AMENDMENTS TO THE DRAWINGS

REMARKS

FIG. 6

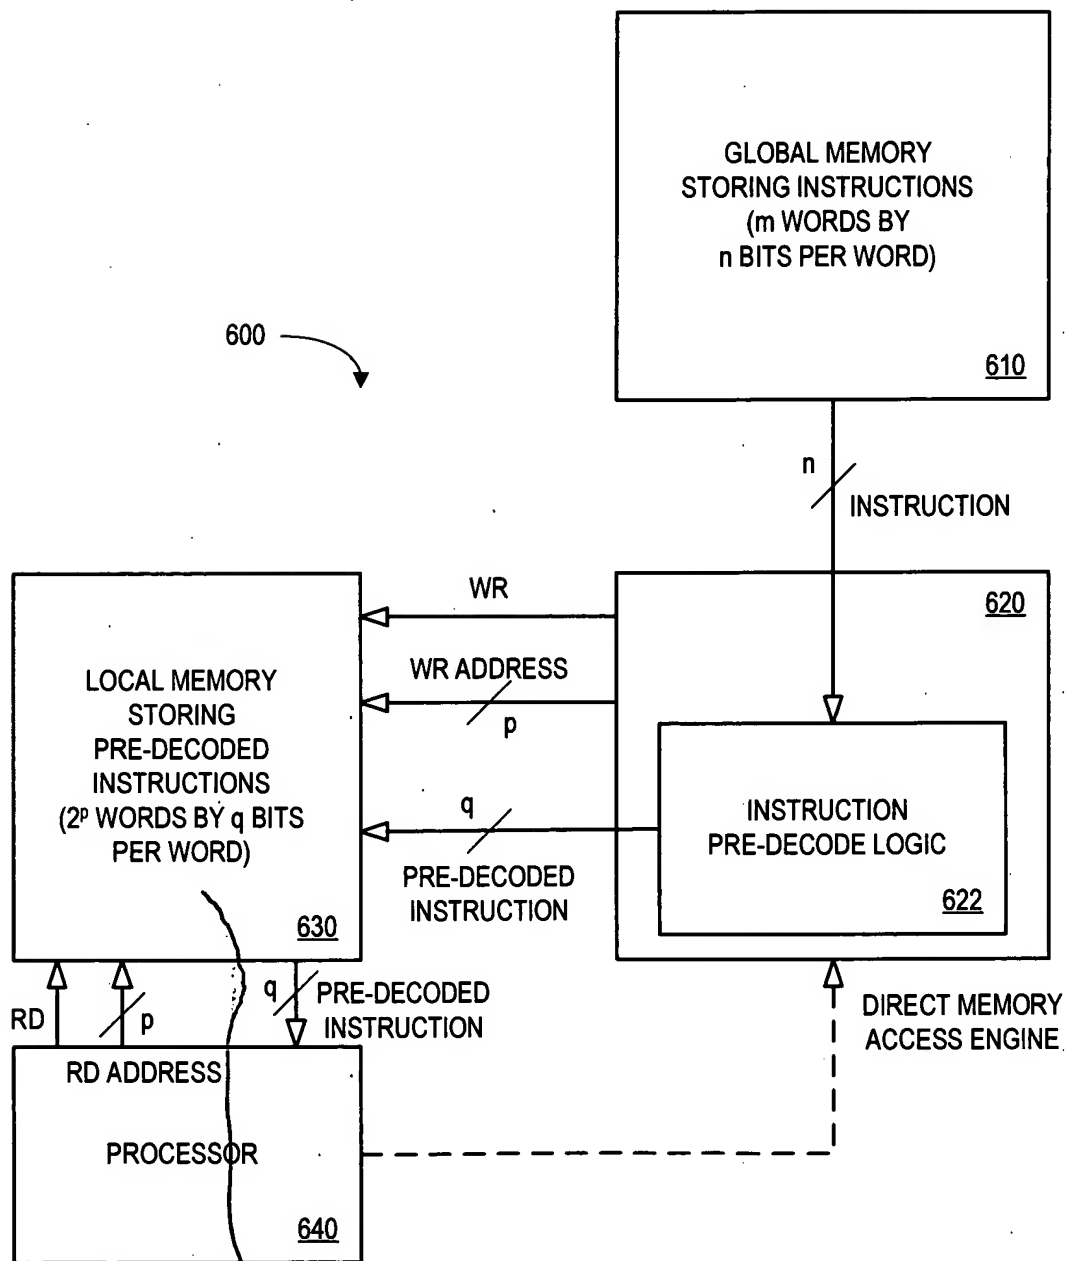
The attached replacement drawing sheet includes changes to FIG. 6. The replacement sheet replaces the original sheet that contained FIG. 6. The replacement sheet adds the phrase “including execution unit control signals and/or flags” to element 630. Support for this change can be found, for example, in the specification at page 5, lines 28-29.

The drawings stand objected to under 37 CFR 1.83(a). FIG. 6 has been amended in view of the Examiner's helpful comments.

INCLUDING
EXECUTION UNIT
CONTROL SIGNALS
AND/OR FLAGS
